**SUBJECT:** Comments on Draft Regulatory Guide DG-1144 and Draft  
NUREG/CR-6909

Comments on Draft Regulatory Guide DG-1144 and  
Draft NUREG/CR-6909

Dominion has reviewed Draft Regulatory Guide DG-1144 and Draft NUREG/CR-6909. The following comments have resulted from that review:

Figure 1. Issue of Transient Linking

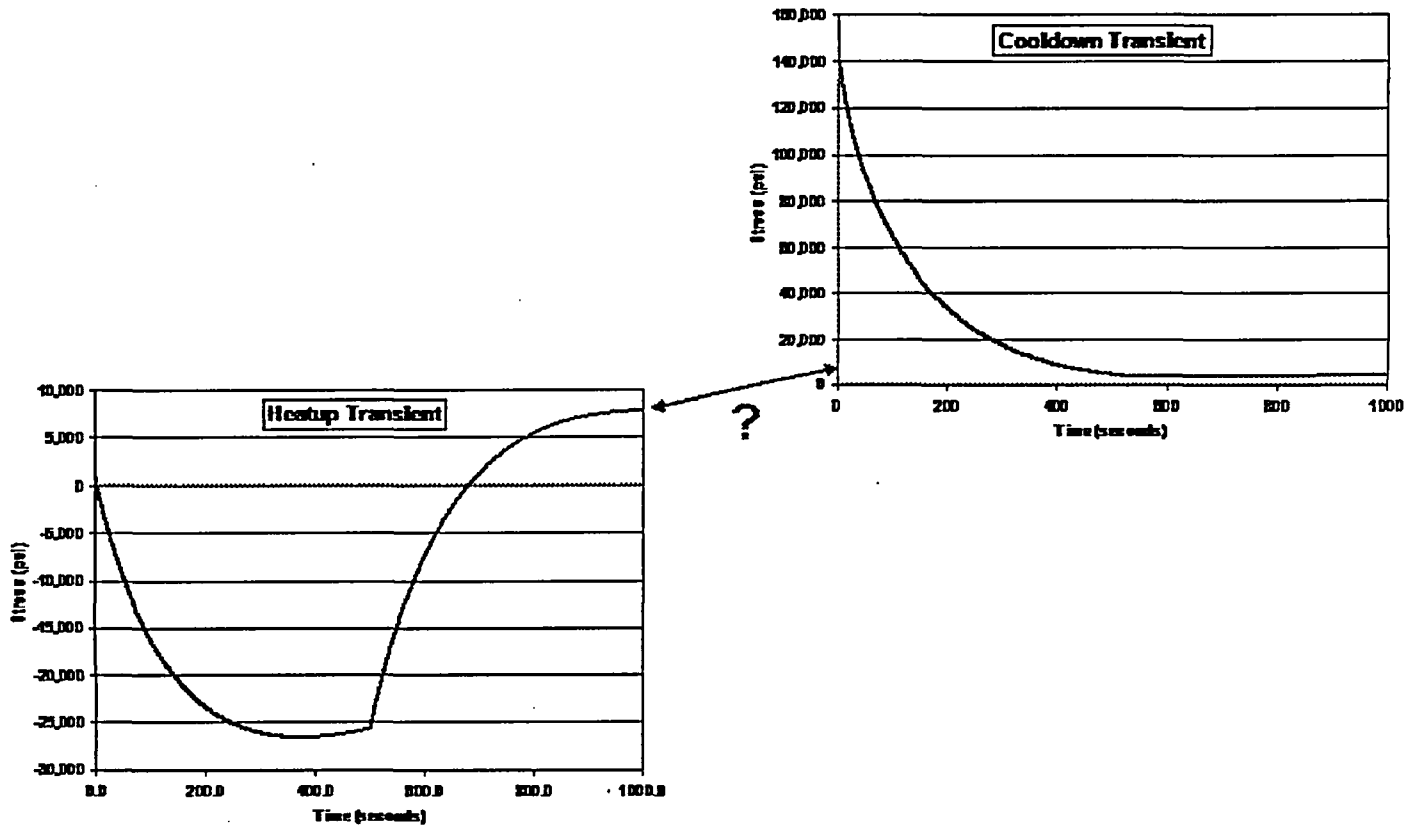
- a. "Linking" of transients pairs is not straight-forward and can lead to significant differences in results (refer to Figure 1) in part due to the following items:
- Treatment of cases where the starting and ending stress points are not equal needs to be clarified
  - The rate of change assumed for the discontinuity between transients needs to be addressed?
  - What is strain rate?

**Recommended change** – Clarify that the recommendations made in Section 4.2.2 of MRP-47, Rev. 1 for addressing linking of transients are an acceptable approach.
